RESPONSE TO COMMENTS

City of Miami Beach,
Wachovia – Alton Road
Response to Building Dept. Cmts.
Page 2 of 4

WACHOVIA - ALTON ROAD BRANCH
1901 ALTON ROAD
MIAMI BEACH, FLORIDA

DESCRIPTION OF WORK:	Construction of New Exterior ADA Ramp; Relocation of ATM & AHD Equipment; Minor Interior Remodel to Create a New ATM Room.
BUILDING CODES:	FLORIDA BUILDING CODE, 2004 EDITION 2004 FLORIDA FIRE PREVENTION CODE NFPA 101, LIFE SAFETY CODE, 2003 EDITION
BUILDING TYPE:	TYPE IIIB
CLASSIFICATION OF WORK:	ALTERATION - LEVEL 2
OCCUPANCY TYPE:	BUSINESS
OVERALL EXISTING BUILDING SQUARE FOOTAGE:	6,085 SF
OCCUPANT LOAD:	1 PERSON/100 S.F. GROSS (6,085 SF/100 SF = 61 PEOPLE)

1 FLOOR PLAN
SCALE: 1/4" = 1'-0"

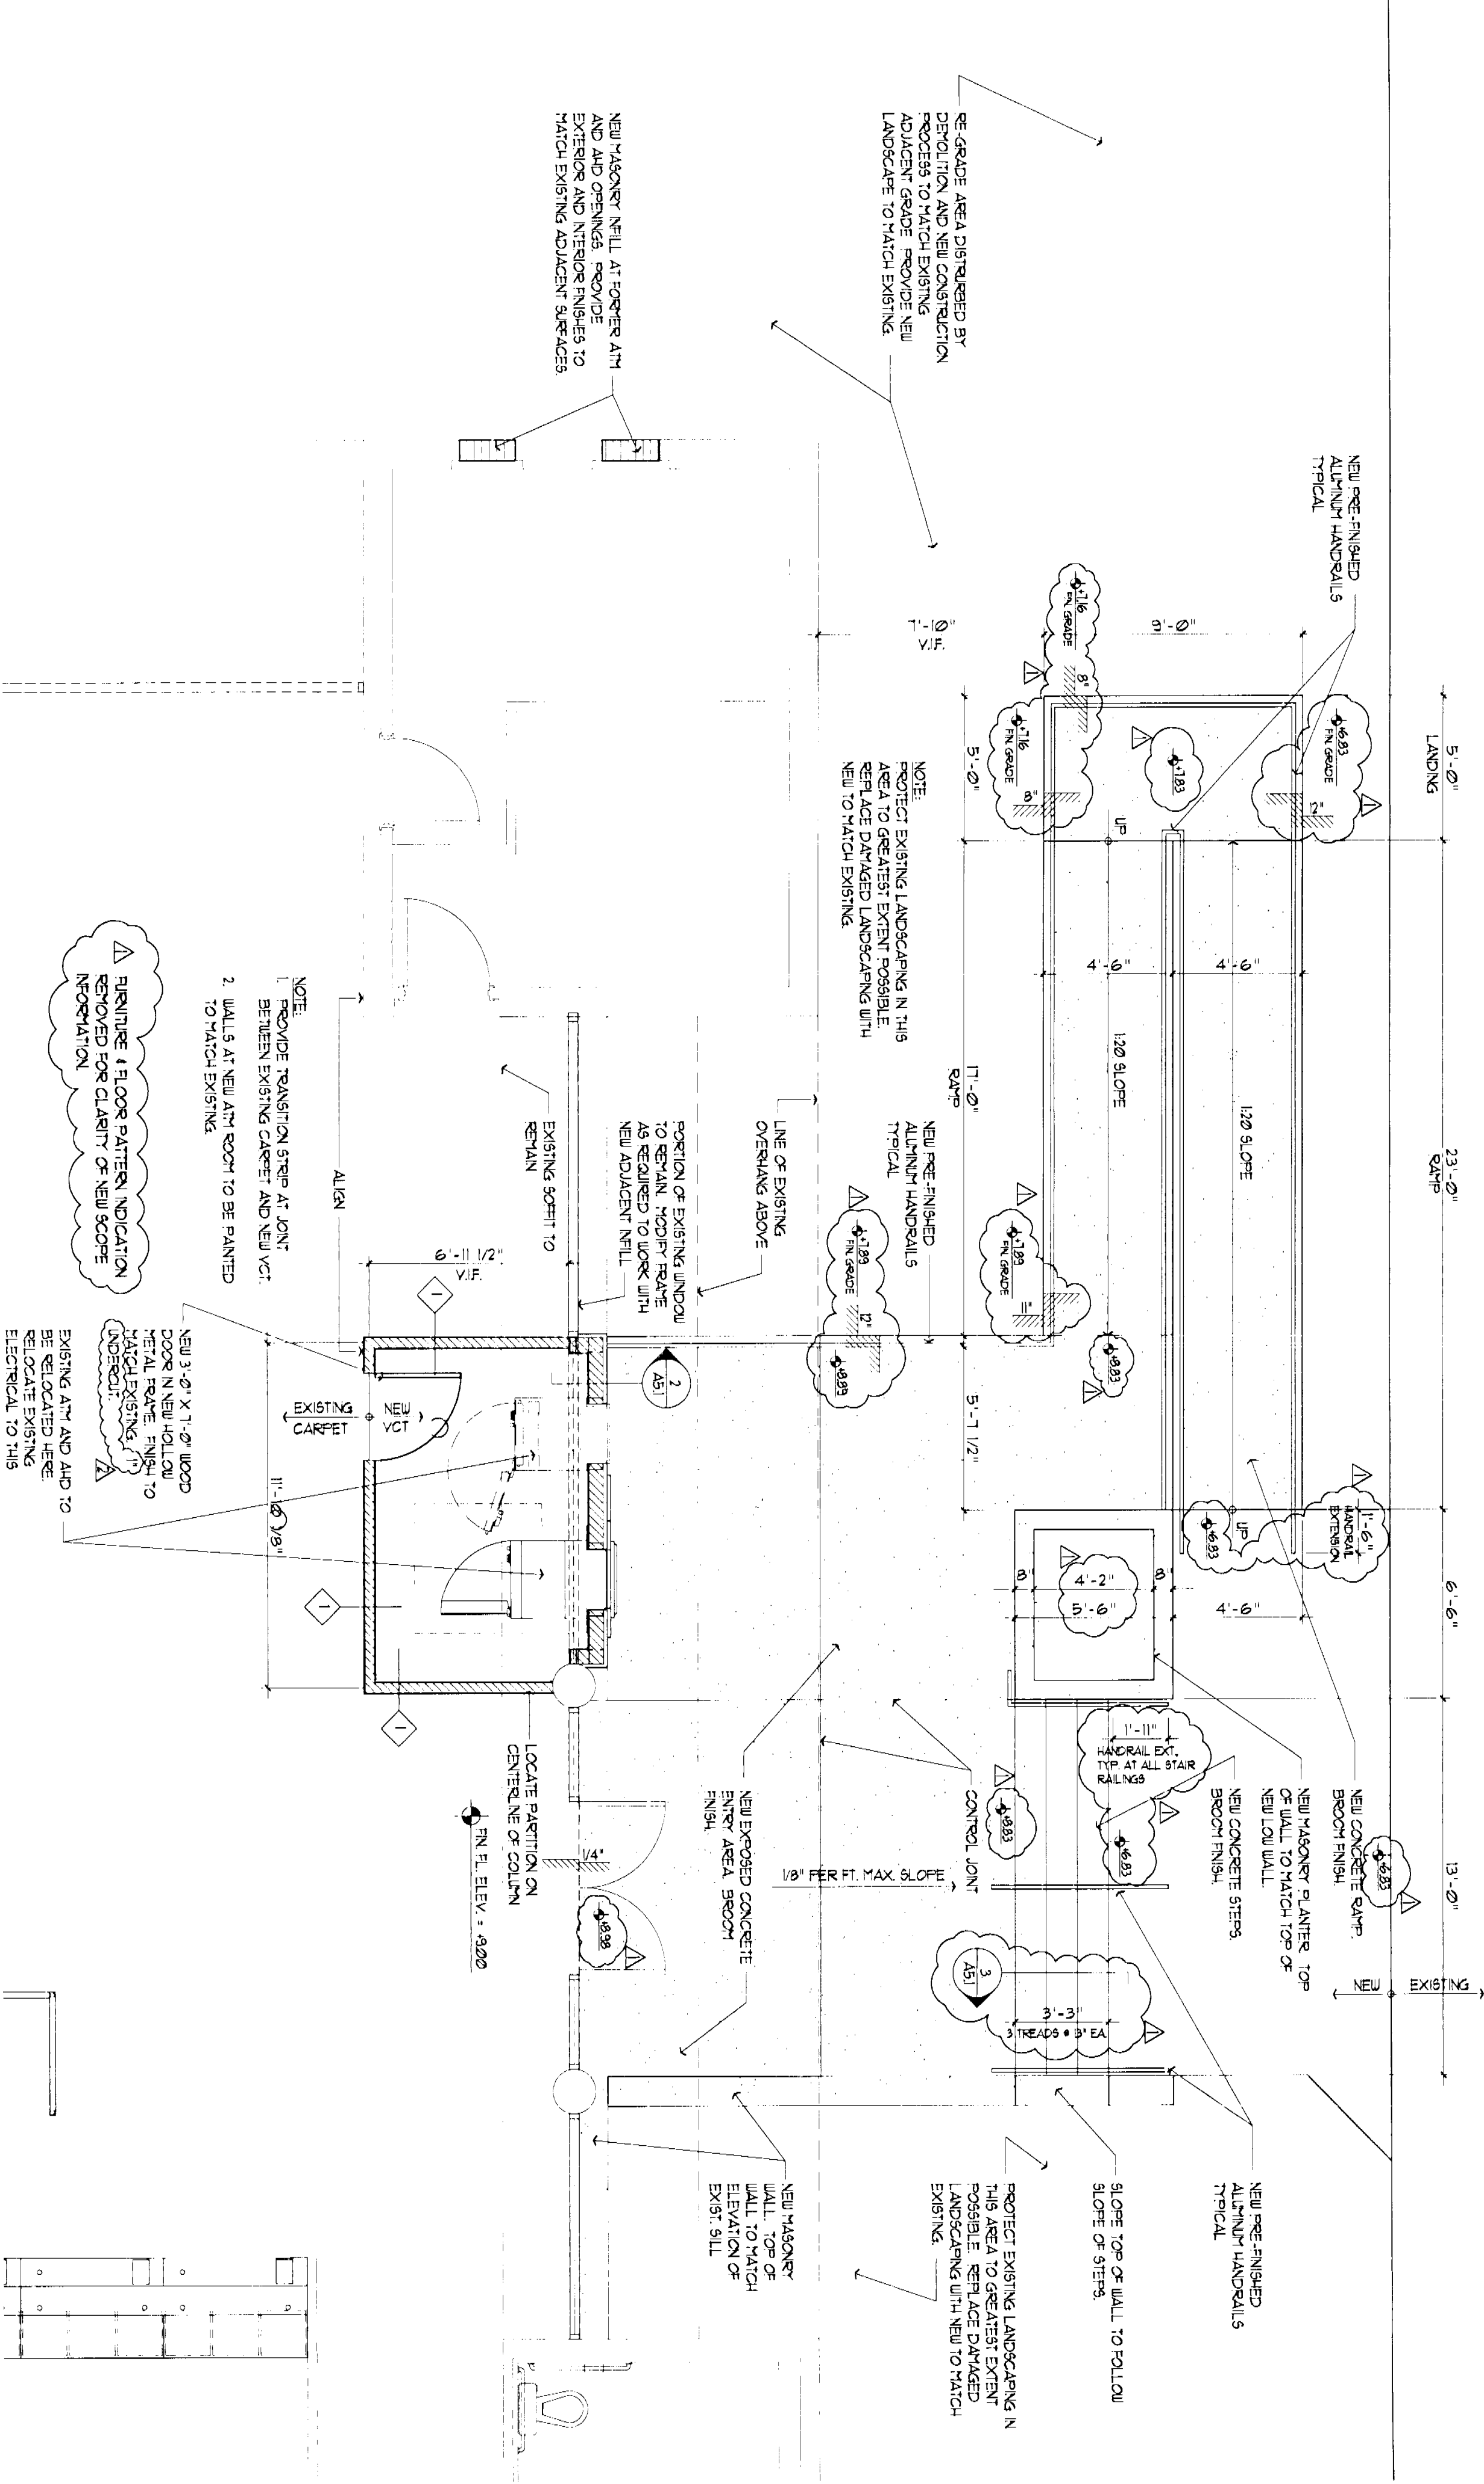
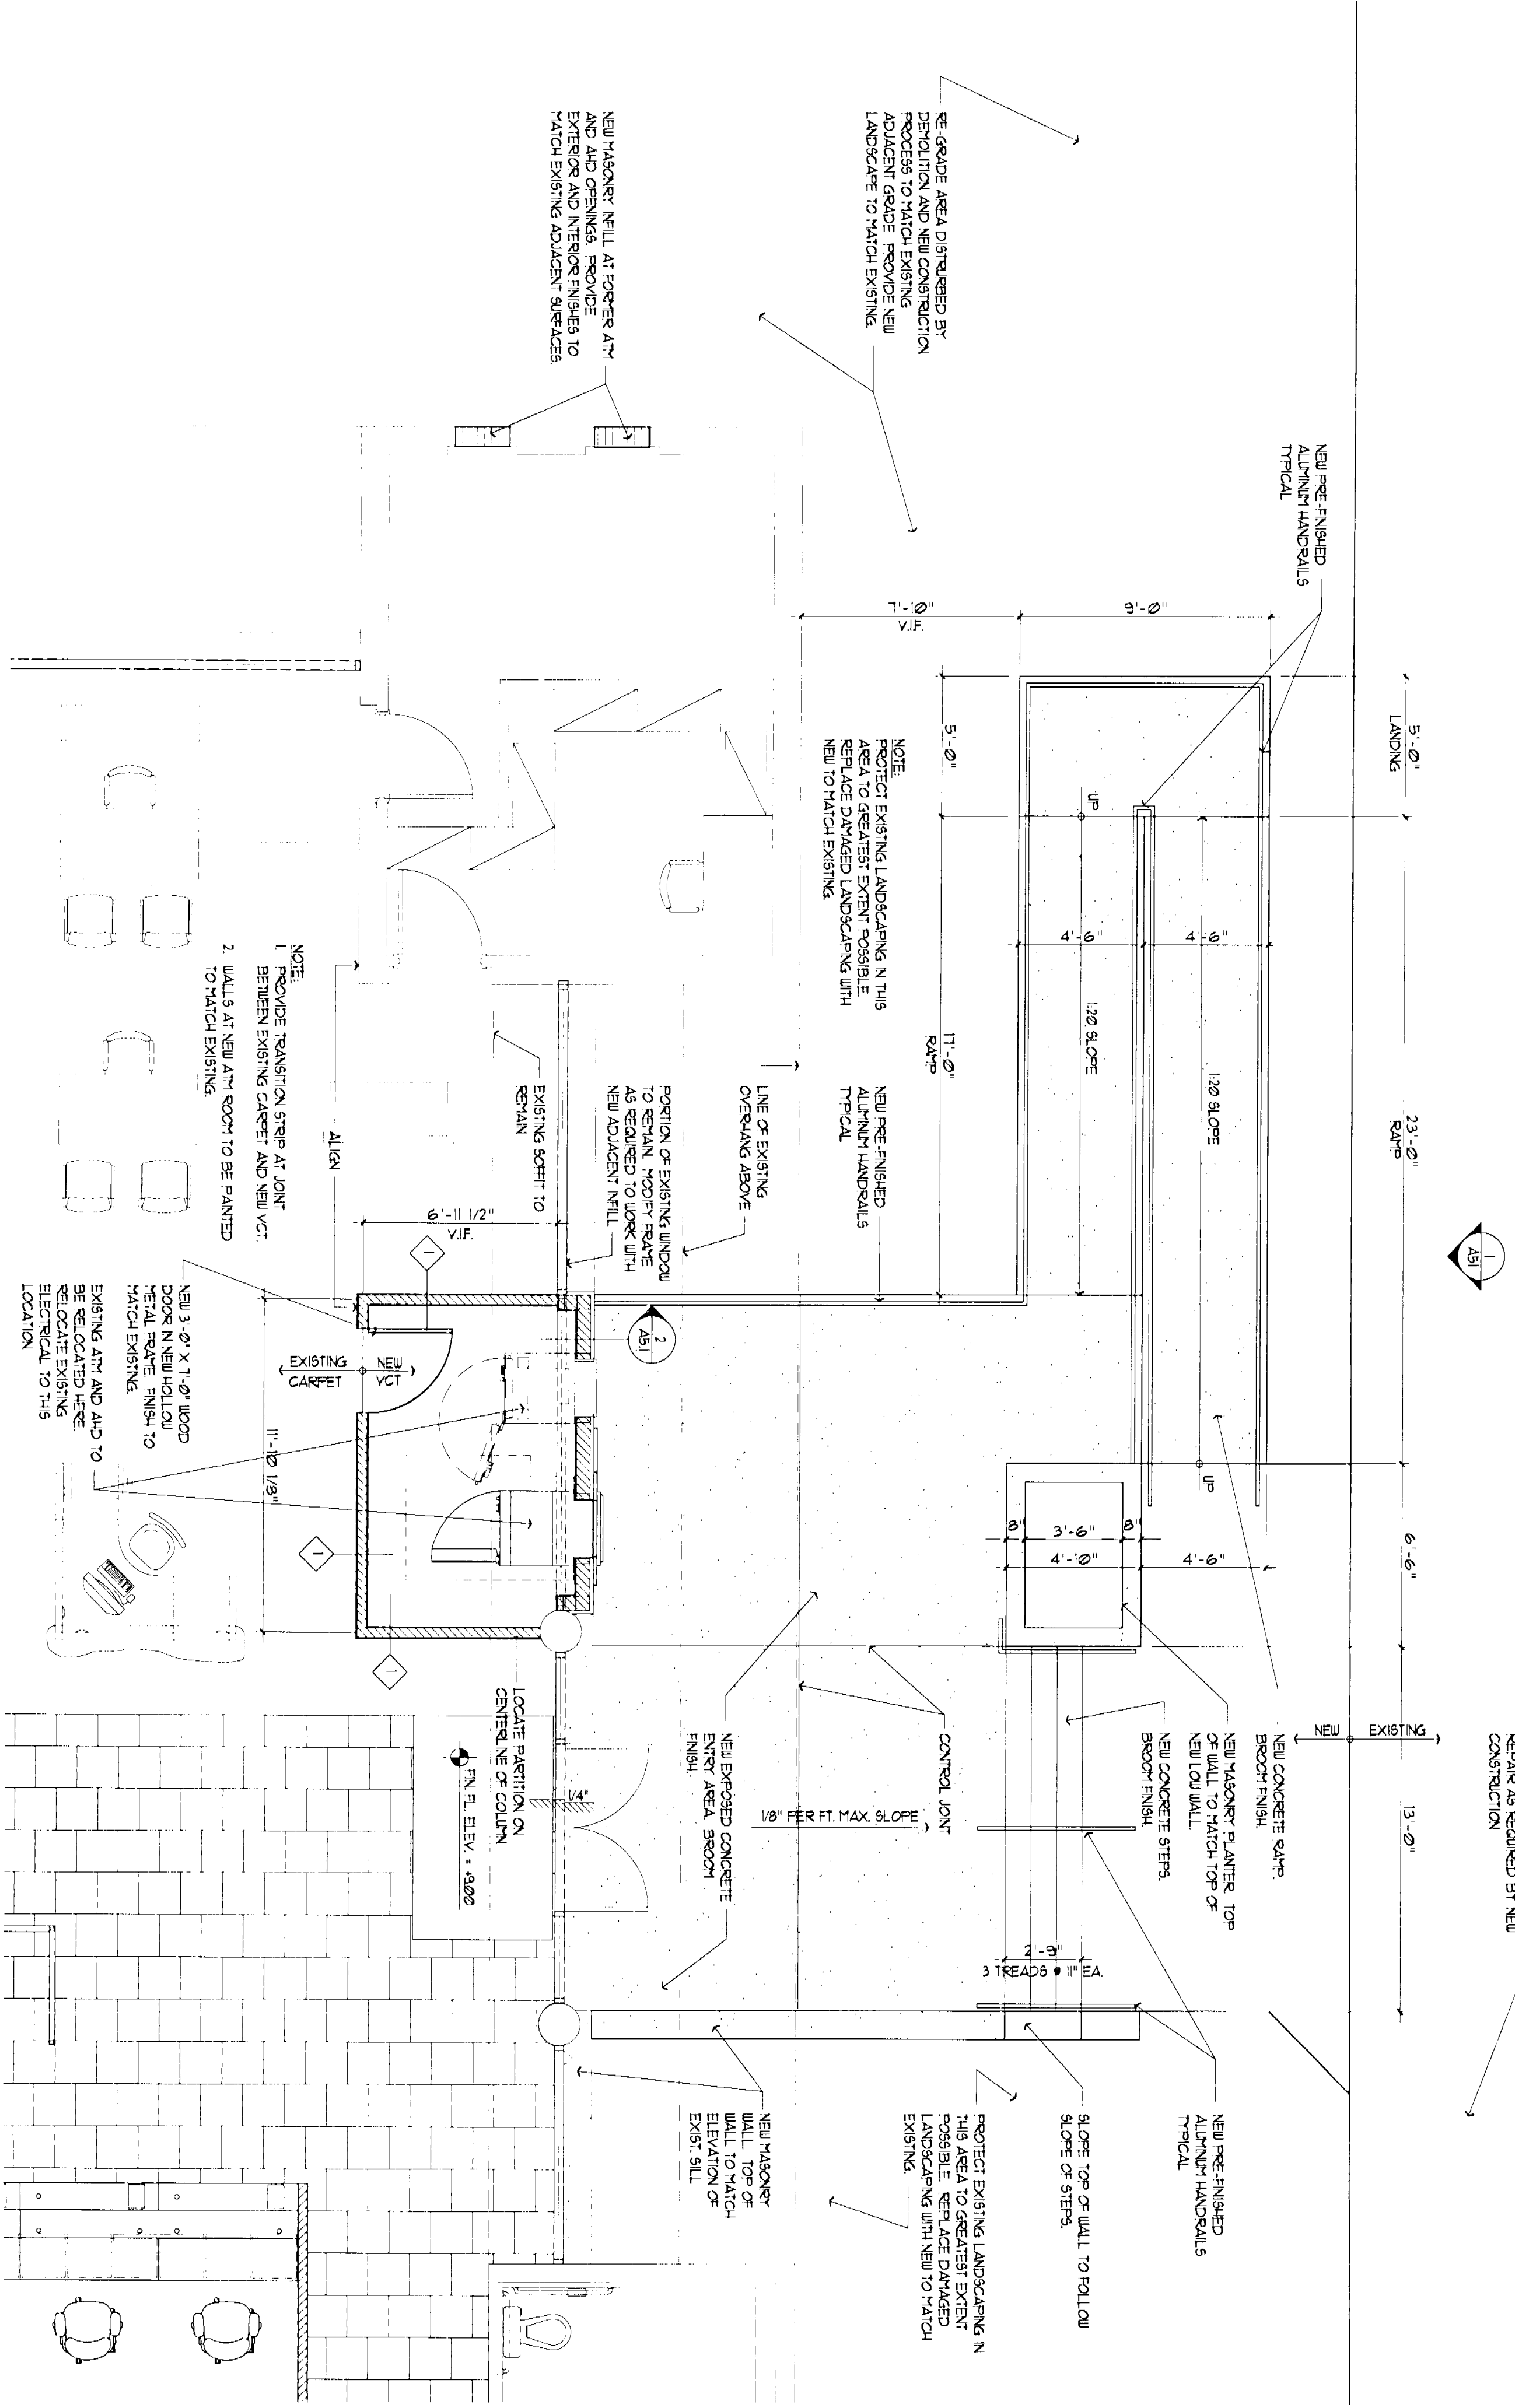
Show and elevation at each surface.

Guards and handrails on both sides shall be provided for ramps. Provide guards and handrail details for ramps.

Provide handrails with their proper extensions along with 3 steps or less need to be 13" min tread with their nosing striped.

Elevation marks have been placed on the Floor Plan. Refer to revised Sheet A1.0 for the information requested.

In accordance with FBC Section 1012.1 and NFPA 7.1.8 guards are required when the open sides exceed 30 inches above the floor or grade below. Please refer to Revised Sheet A1.1 for the applicable grade elevations. The landings and portions of the ramp are, at their maximum, 12" above the grade. Therefore handrails have been provided as opposed to guards.

Refer to Revised Sheet A5.1 and new details 3/A5.1 and 5/A5.1. Section 3/A5.1 indicates the required extensions at the handrails. Section 5/A5.1 calls for stair nosings with an anti-slip abrasive texture and color safety yellow. Refer to Revised Sheet A1.1 for the revised tread dimensions. Treads have been modified to be 13".
